JUN 13 1997
DOE-1069-97

**TRANSMITTAL OF THE SITE PREPARATION PLAN FOR AREA 2, PHASE I - INACTIVE
FLYASH PILE, SOUTH FIELD AND ACTIVE FLYASH PILE (SOUTHERN WASTE UNITS)**

- **A revised Site Preparation Plan for Area 2, Phase I (Revision B)**
- **Riser Pipe detail**
- **Cross-sections and plan sheet with locations**

AREA 2, PHASE I SITE PREPARATION PLAN

DRAWING TITLE
SKETCH #2

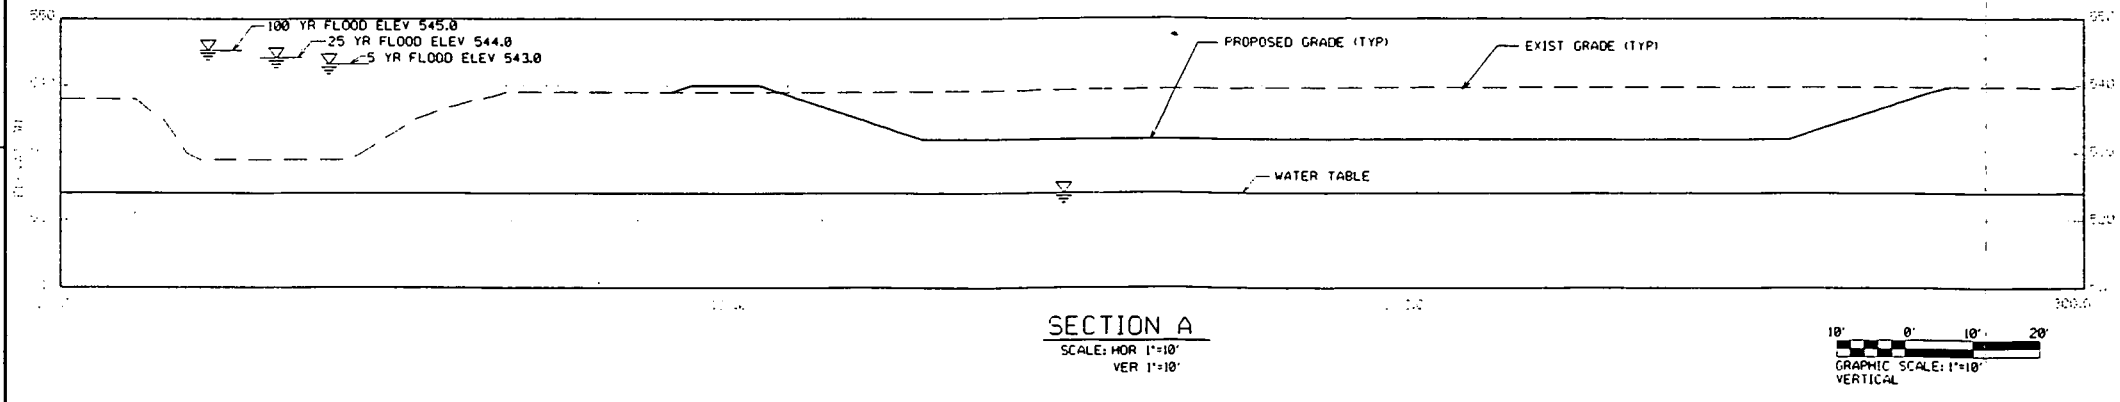
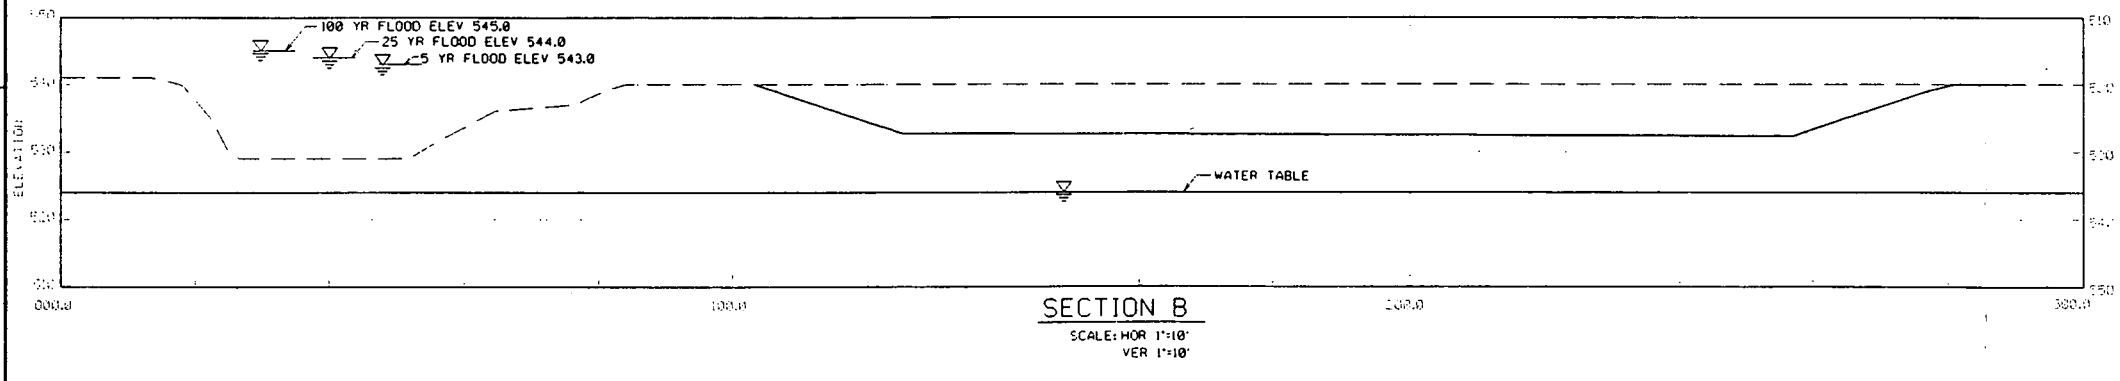
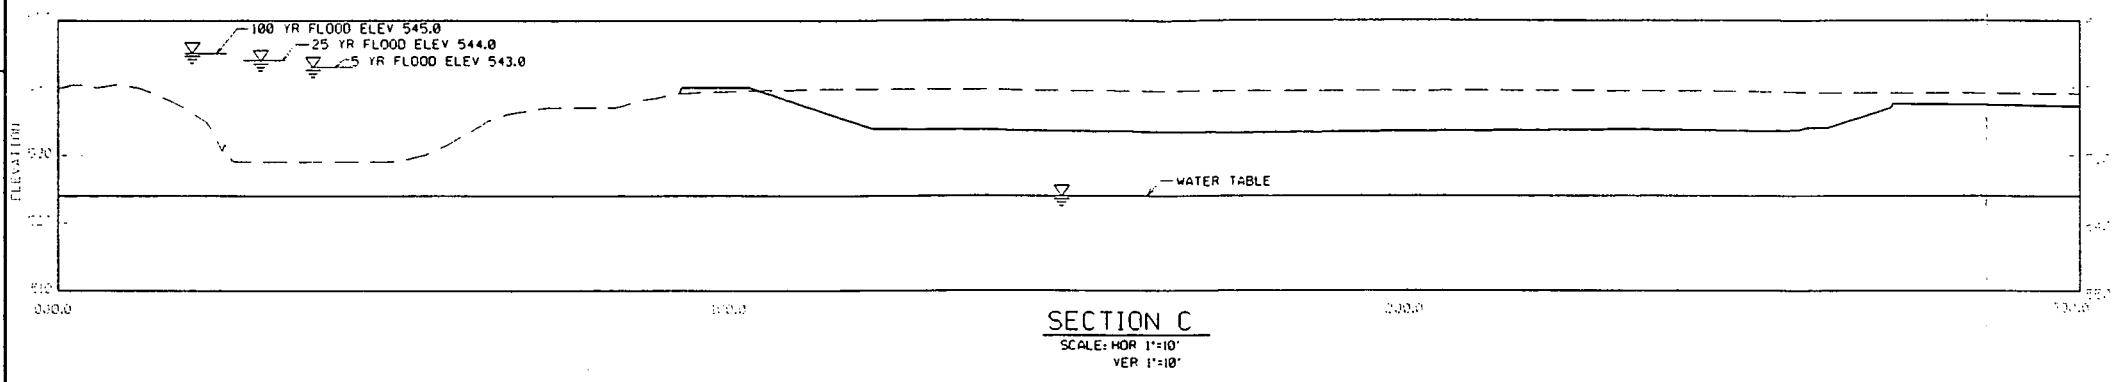
- **Cross-sections and Paddys Run Flood Stage.** Three cross-sections were cut through the portion of the ditch where it is in closest proximity to both the inactive flyash pile (IFP) and Paddys Run, and three cross-sections were cut through Basin 1 and Paddys Run. These cross-sections and a plan view with their locations are attached.

The IFP/Paddys Run cross-sections show that a ditch can be constructed in the area; the final location of the ditch will be determined in the field. Elevations of flood waters, resulting from 5, 25 and 100-year, 24-hour storm events, within Paddys Run in the proximity of the IFP area are as follows:

Elevation of the GMA groundwater levels are shown on the Basin 1 cross-sections. This information demonstrates that the groundwater levels are below the bottom of the basin.

SIDE VIEW RISER PIPE DETAIL

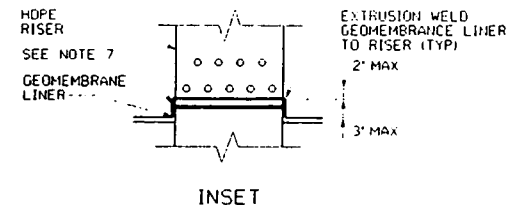
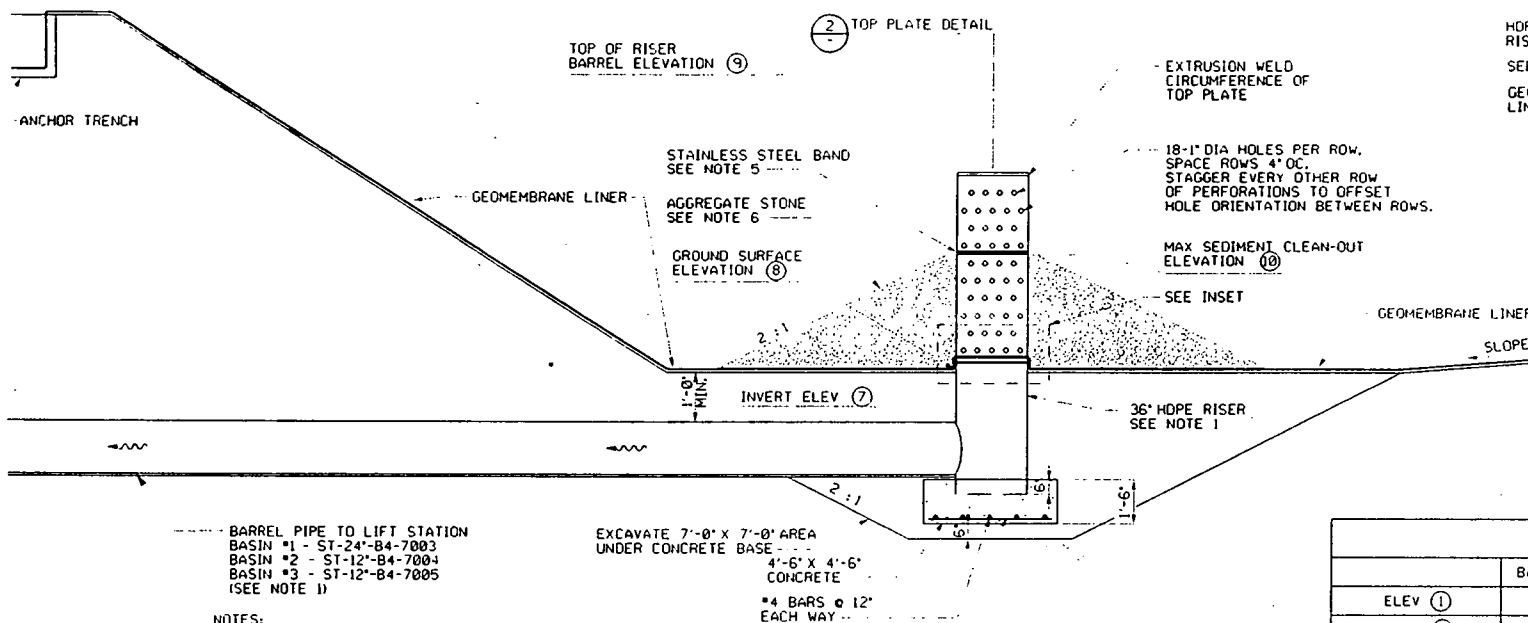
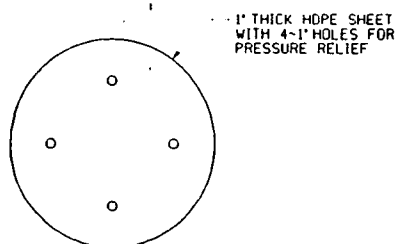
- **Basin Dewatering.** The riser pipes in all three basins were revised so that the basins will have the ability to completely dewater via gravity. The HDPE riser pipes in all three basins will be perforated to the bottom of the basins. The perforations will be one inch diameter holes. Aggregate with an approximate size of two inches will be piled against the riser to the sediment clean-out level. The aggregate will filter and slow the flow into the riser without excessive restrictions while providing the ability for the basins to dewater via gravity flow.
